**Re: 45 Park Place
New York, NY
B4176.00**

**45 Park Place – Peer Review
B4176.00**

December 12, 2014

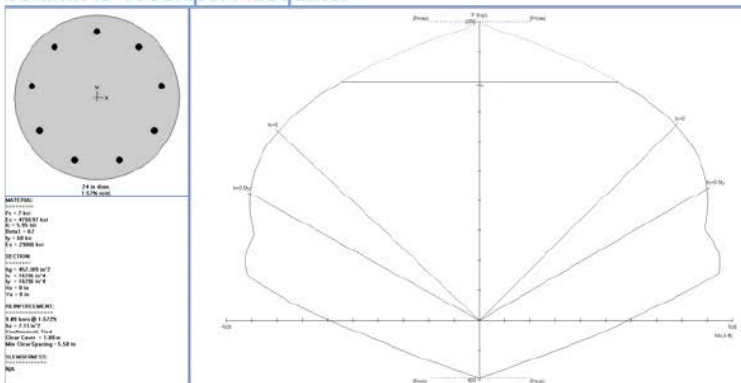
- a) • Column 1 on the 37th floor
 Column 1, supporting floor 38 is 7ksi 24" round with 9-#8 and demand of 1578kips. Capacity for this column is 1600kips. Adequate.

This is adequate.

b) • Column 2 on the 1st floor and the 37th floor
Column 2

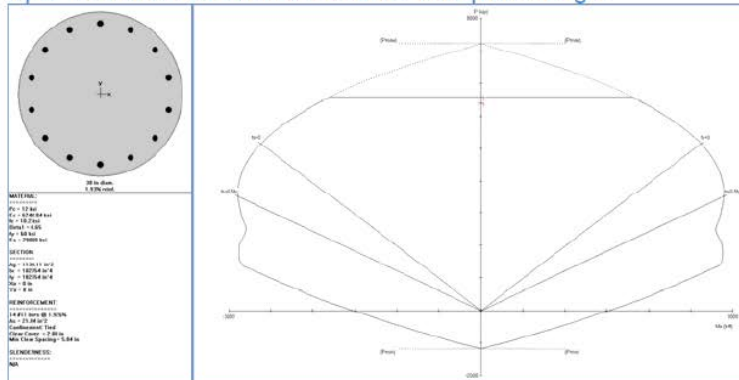
- Supporting floor 2 is 38" round with a capacity of 6500kips, demand shown in 12FAR column schedule was 6578 kips. We have increased the reinforcement to 14-#11, with a capacity of 6580 kips. See attached column schedule. Adequate design.

Beam at mezzanine is only bracing the column in one direction please provide calculation to showing the beam is sufficient to brace the column out of plane.

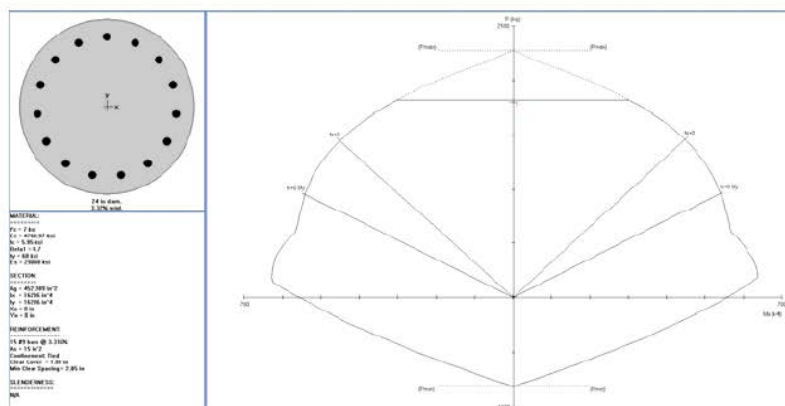
- Supporting floor 38 has a capacity of 1820kips, and demand of 1800. Adequate design.

This is adequate.

c) • Column 3 on the 1st floor and 11th floor
Column 3

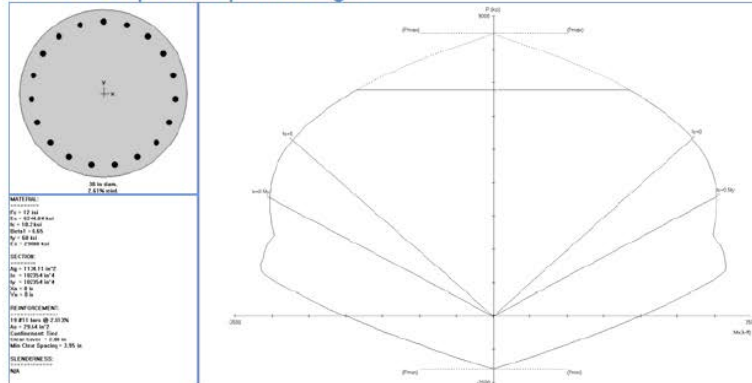
- Supporting floor 2 is 38" round with a capacity of 6780kips, demand shown in column schedule was 6778 kips. Adequate design.

This is adequate.

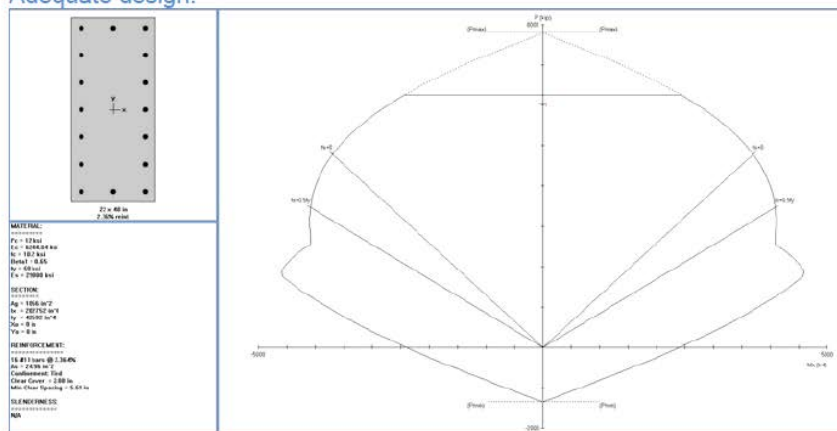
- Supporting floor 12 is 22x48 with 16-#11. Demand is 6050 kips and capacity is 6250 kips. Adequate design.

This is adequate.

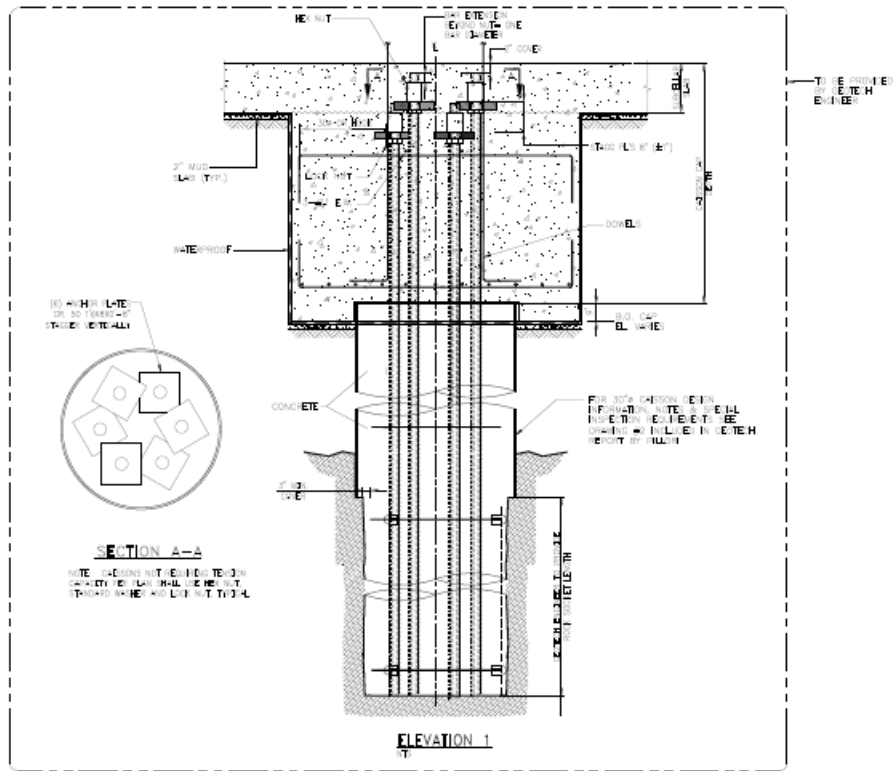
- j)
- S-130.00 shows reinforcement top, bottom and mid-depth of slab with what appears to be anchor plates at the end of the bars. The plates are not called out or detailed. Please clarify. These bar ends indicate Lenton terminator heads, a note has been added to drawings.

This is adequate pending 100% CD.
